Reference: Palmer Village, LLC
Review of Sketch Plan

I am in receipt of a new sketch plan submission titled "Sketch Plan - Proposed Palmer Paddocks", as prepared for Palmer Village, LLC, by Bohler Engineering. This plan consists of three (3) sheets, and is dated July 16, 2020 with no revisions. This plan shows a proposed subdivision and land development plan for the 50 acre tract at the northeast corner of Skippack Pike and Valley Forge Road. It should be noted that a preliminary subdivision plan was previously submitted for this same parcel and reviewed by the Township. The latest engineering review letters for that preliminary subdivision plan are dated October, 2017. Also, Sketch-Concept Plans D and E were recently submitted to the Township and my review comments for those sketch plans were included in letters dated April 30, 2020 and May 12, 2020. This latest sketch plan is different from the preliminary subdivision plan submitted in 2017 and also the recently submitted Sketch-Concept Plans D and E. Based on my review of this latest sketch plan, I offer the following comments:

RE: **Traffic Review #1 – Sketch Plan Review**
Palmer Tract Mixed-Use Development
Worcester Township

E & S CONTROL AND DETAILS

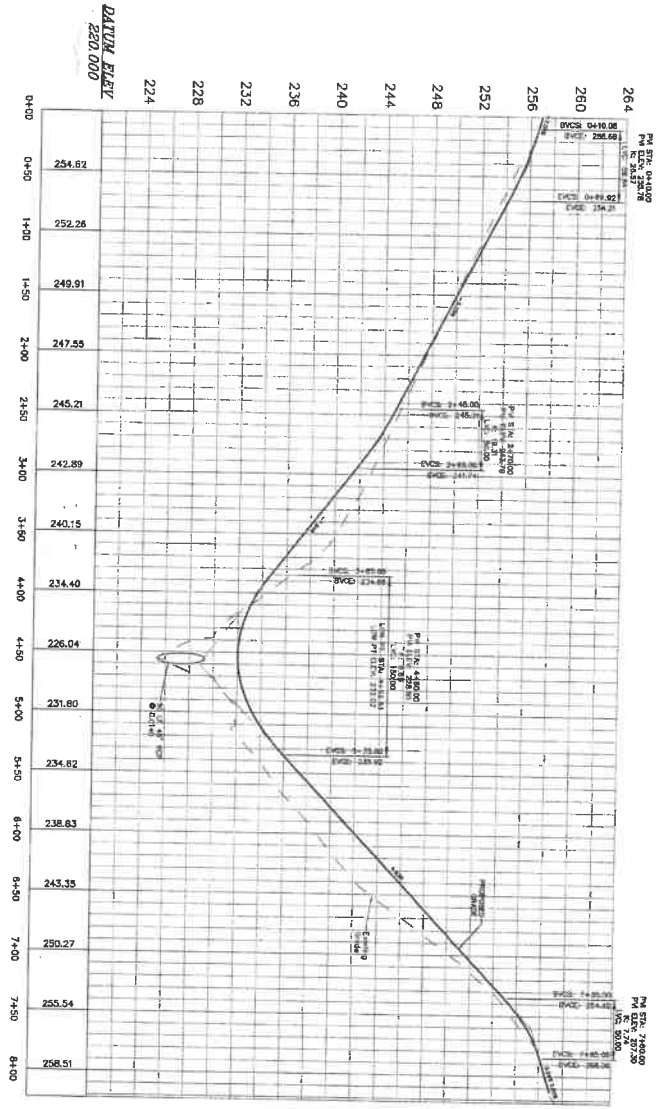
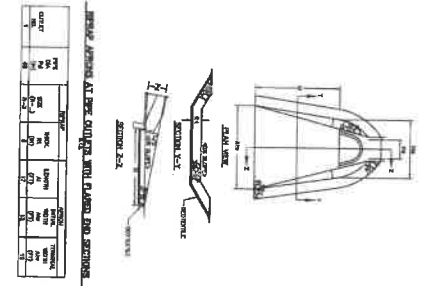
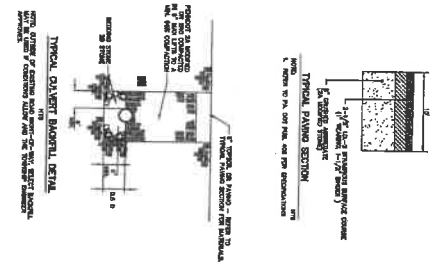
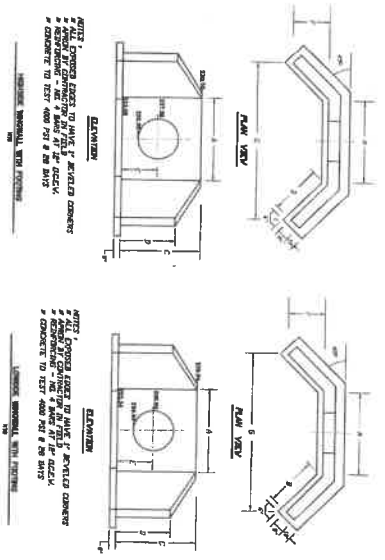
1. The management plan should be revised to include the boundaries of Zones 1 and 2 of the riparian corridor. (Section 150-146.12.A.(1))
2. The Corridor Management Plan should be revised to included the goals established in Section 150-146.5 of Township Code and describe how this crossing will impact the goals set forth in that section for this property.

4. The Corridor Management Plan lists numerous plant species that are compatible with planting in a riparian corridor. However, there is no indication of where these plantings would be located in conjunction with the proposed plan. It is suggested that the area within the riparian corridor be drawn to a larger scale, and proposed landscaping should be located on that plan.

5. The Corridor Management Plan should provide additional information on how the disturbance, and impact of the crossing will be mitigated on the site. As a suggestion, the applicant's engineer should look at the existing crossing that is to be abandoned with the existing driveway. It may be beneficial to place additional riparian plantings at that location to offset the disturbance created by the new driveway.

The applicant's consultant should refer to Section 150-146.5, and 150-146.12 to determine the specific requirements of the plan. It may be advisable to submit a supplemental written report in conjunction with the plan sheet. In addition, the applicant's consultant should provide the Township with the calculations for the sizing of the new stream crossing. The plans show a 48" diameter pipe, but the calculations for determining that pipe size should be provided for review.

SHEET NUMBER: 1

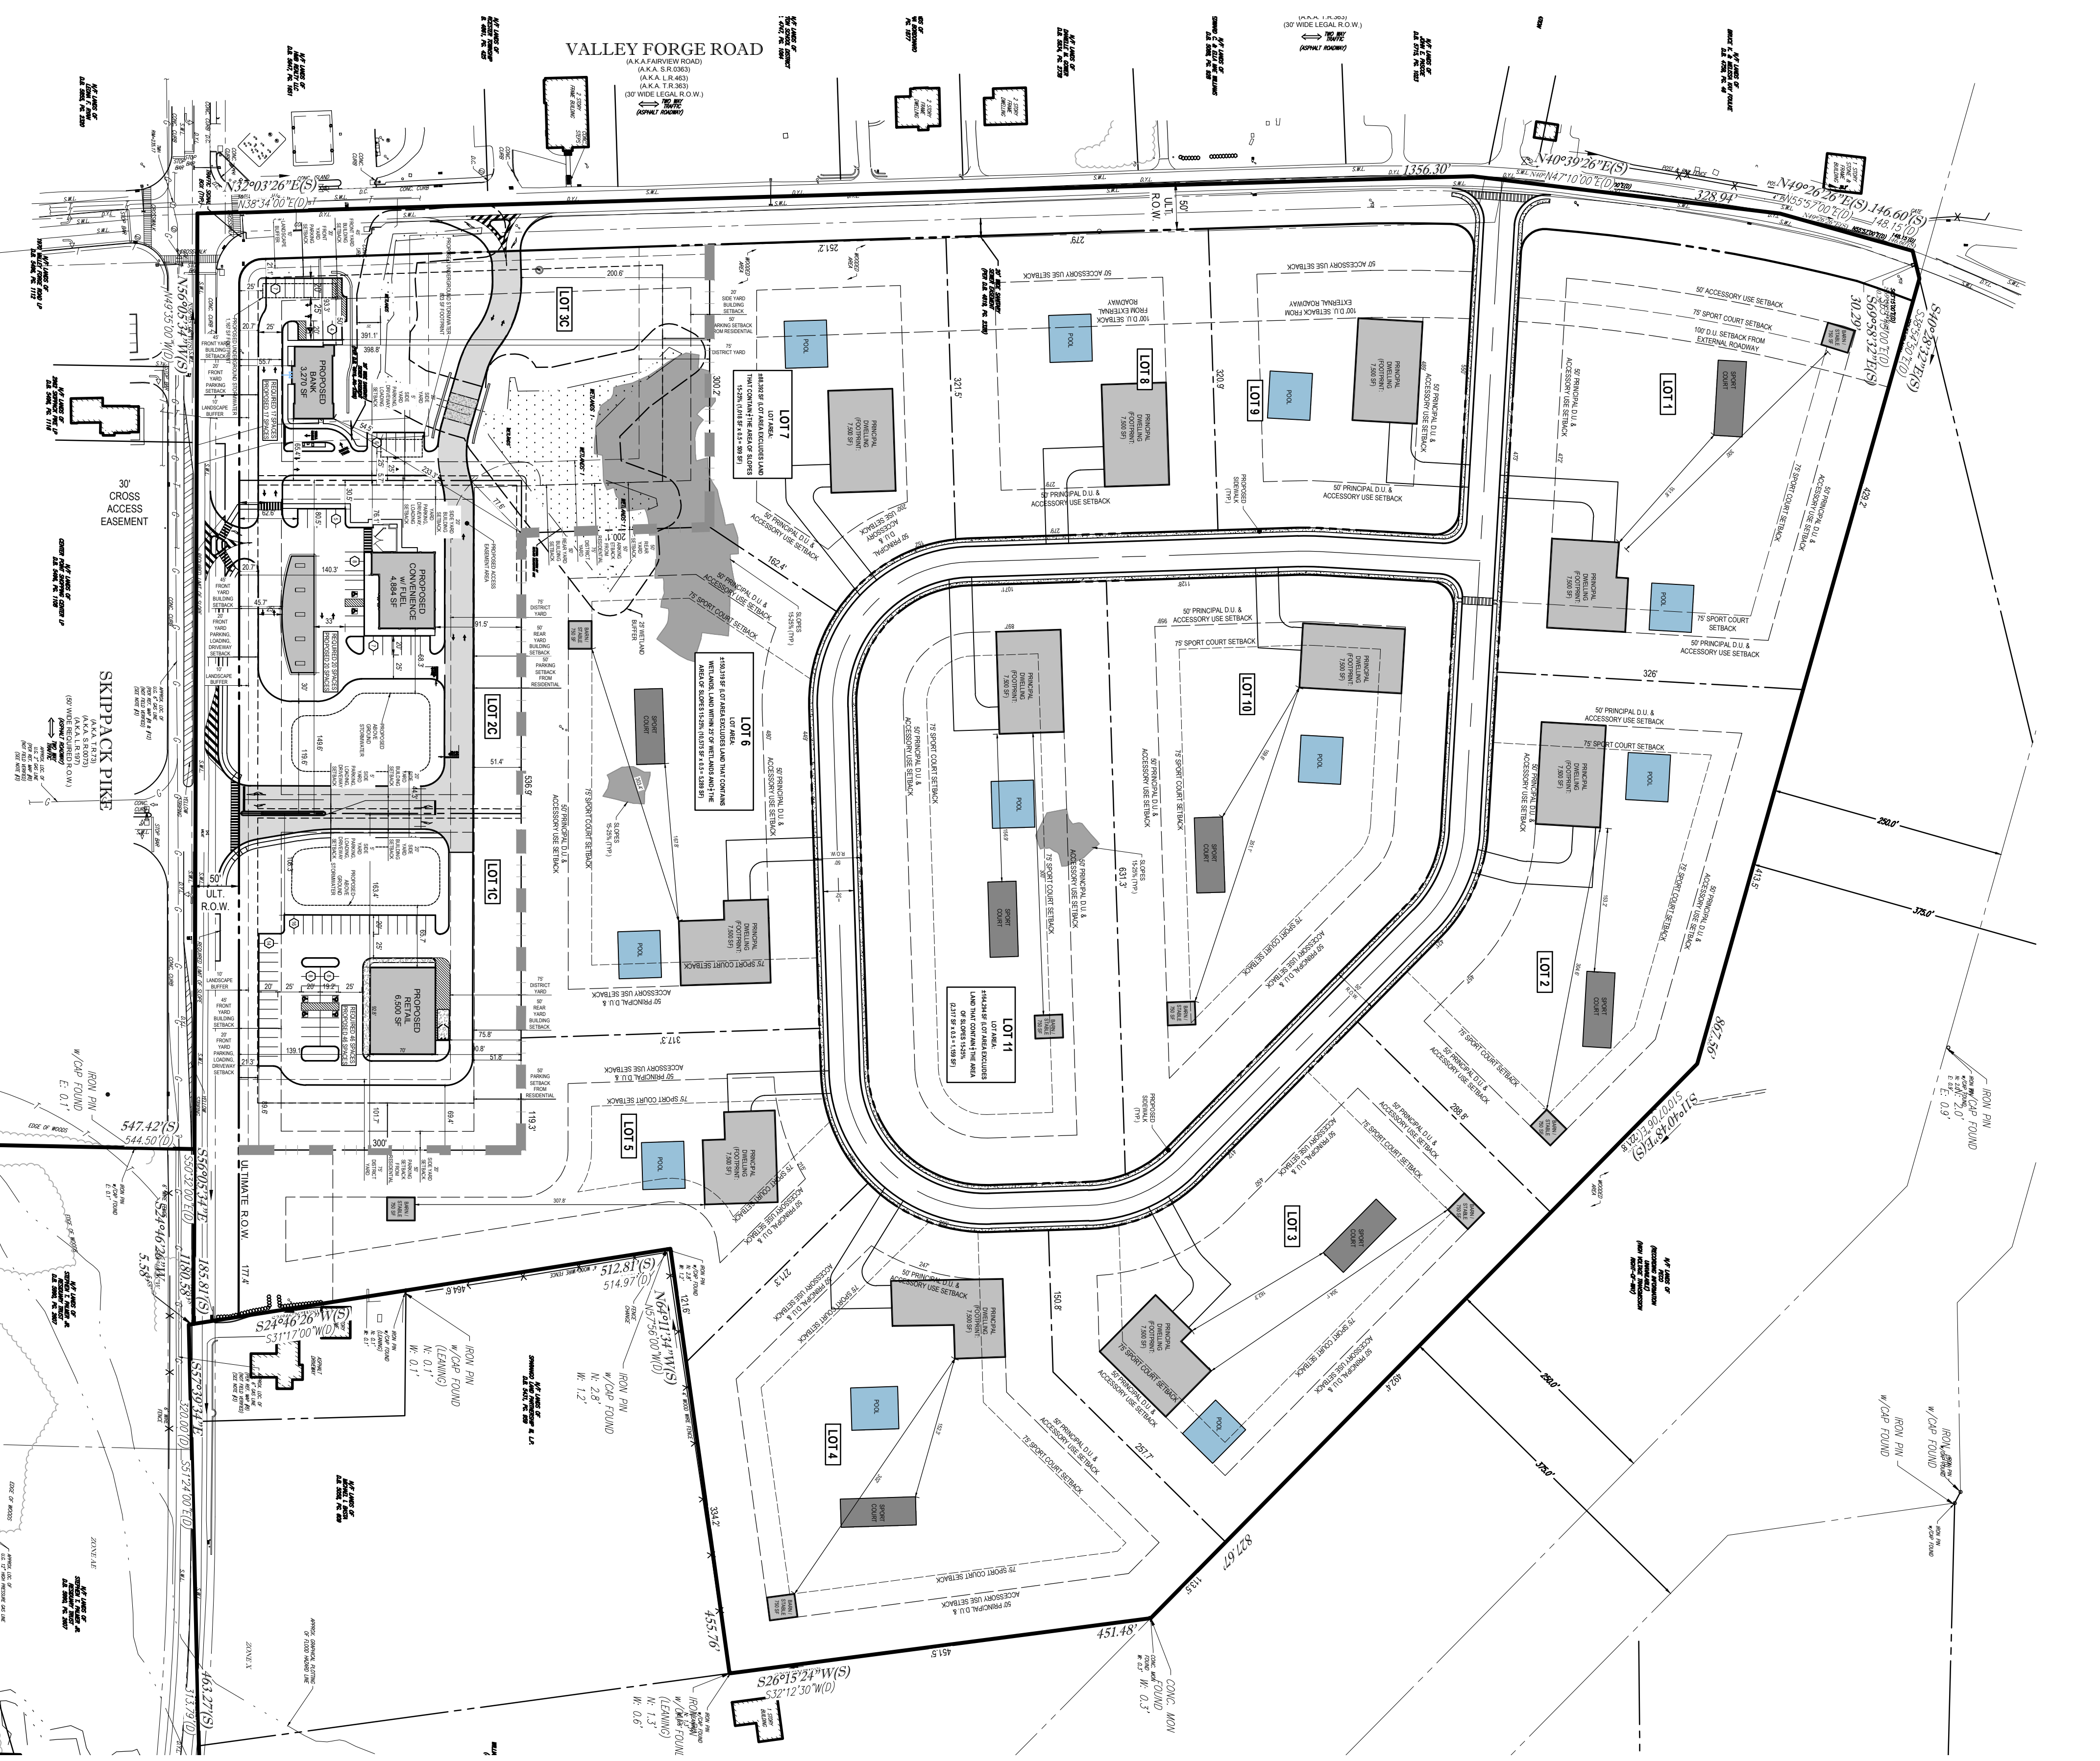
7. Sheet No. 1 is entitled "Existing Conditions". This plan shows the location of a sanitary force main, which passes through the property, crosses Skippack Pike, and eventually works its way to the Valley Green Wastewater Treatment Plant. This force main connects to the Meadowood pumping station, and is owned by the Township. The pumping station

serves the Meadowood Development and also the Methacton Elementary School. An easement should have been provided through the Palmer Property in conjunction with the location and construction of this sewage force main. This easement is not shown on the plan. This easement should be shown not only on the existing conditions plan but also the sketch plan, as there are potential concerns with conflicts with the existing force main.

8. There is an air release chamber on the Meadowood force main on the Palmer Property. This chamber is approximately 930 ft. from Skippack Pike (See Attached Exhibit). This should be added to the plans. This will also verify the location of the pipe.

SHEET NUMBER: 3

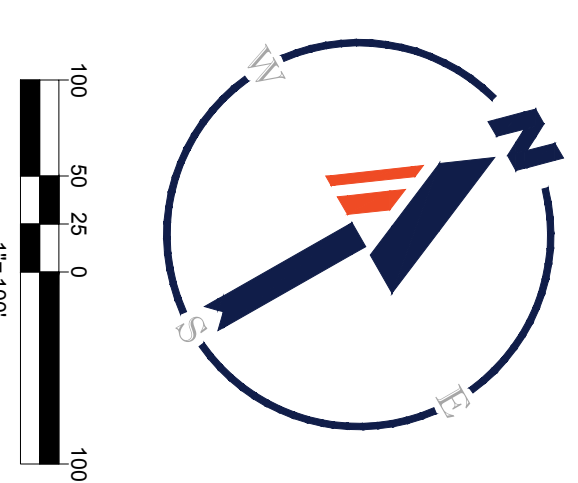
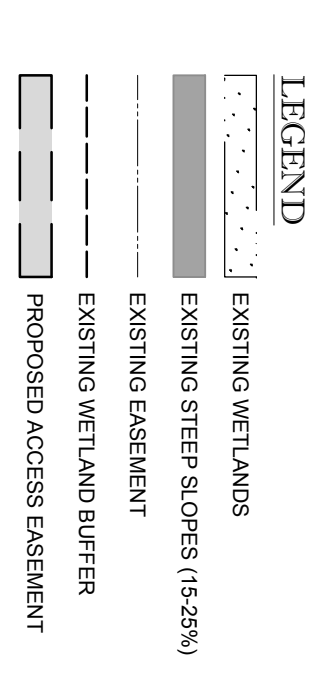
2. The proposed convenience store is shown with fueling stations. The plans include a note (Sheet 3, Zoning Table) that states a gasoline service station is permitted by special exception. The Township Zoning Officer should review the proposed use and determine if gasoline/fueling stations are permitted in conjunction with a convenience store use. Section 150-112.1.(5).

- through 14. Sheet No. 3 includes an overall lot calculation table which references lot 1, 2, and 3, but they are in fact the commercial lots (1C, 2C, and 3C). Renumbering the lots from 1 to 14 and revising the tables as required will avoid confusion in reviewing the plans and subsequent recording of the lots.

4. The three (3) commercial lots have been subdivided in accordance with the requirements of Article XVII, which is the "C" - Commercial District. A table of these three lots and the zoning requirements are shown on Sheet 3. The commercial lots are identified as 1C, 2C, and 3C, and as mentioned above, the lot numbering should be revised.

5. The residential portion of the lot is 1,696,120 sq. ft, as determined by the "overall lot area calculations" table on Sheet 3. This property is in the LPD zoning district, however, the residential portion must be developed in accordance with Article XVIA-Conservation Subdivision District. The applicant has chosen Option 2 to determine the allowable density on the residential property. Using Option 2, the total number of allowable building lots is 11. The layout plan for the residential portion was based on 11 lots and the specific dimensional information on each lot is contained on Sheet No. 3. Again, residential lots are labeled lots 1 through 11 and the lot numbering should be revised the new lot numbering for the overall plan. Based on my review of the Zoning Ordinance requirements and the calculation provided on Sheet 3, the applicant has accurately determined the number of residential dwelling units permitted on the residential portion of the property. It should be noted that there is no open space requirement associated with Option 2 in the Conservation Subdivision District.
